**UNITED STATES  
DEPARTMENT OF THE INTERIOR  
BUREAU OF LAND MANAGEMENT**  
Sundry Notices and Reports on Wells

5. Lease Number  
NM-66816. If Indian, All. or  
Tribe Name7. Unit Agreement Name  
Federal C8. Well Name & Number  
#39. API Well No.  
30-043-2082610. Field and Pool  
Alamito Gallup11. County & State  
Sandoval County, NM2. Name of Operator  
Questar Exploration & Production Company3. Address & Phone No. of Operator  
1050 17<sup>th</sup> Street, Suite 500, Denver, CO 80265

# PLUG AND ABANDONMENT PROCEDURE

Attachment to Notice of Intent for Permanent Abandonment:

## Proposed P&A

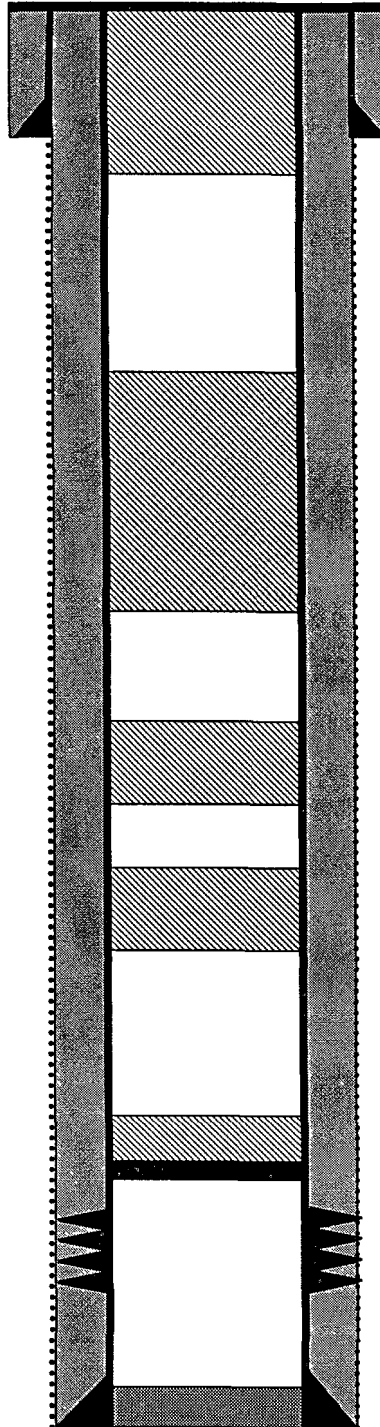
- 1.) Plugging operations authorized are subject to the attached "General Requirements for Permanent Abandonment of Wells on Federal and Indian Leases."
- 2.) Farmington Field Office is to be notified at least 24 hours before the plugging operations commence. (505) 599-8907.
- 3.) The following modifications to your plugging program are to be made:
  - A.) Extend the Gallup Plug #1 from 4636' to 4436'.
  - B.) Move the Mesaverde Plug#2 to 2083' - 1983'.
  - C.) Extend the Pictured Cliffs to Ojo Alamo Plug #4 from 1328' to 640'.

Plug #4: 1328'- 660'  
Class G cement, 55 sxs

Plug #2: 2802'- 2702'  
Class G cement, 12 sxs
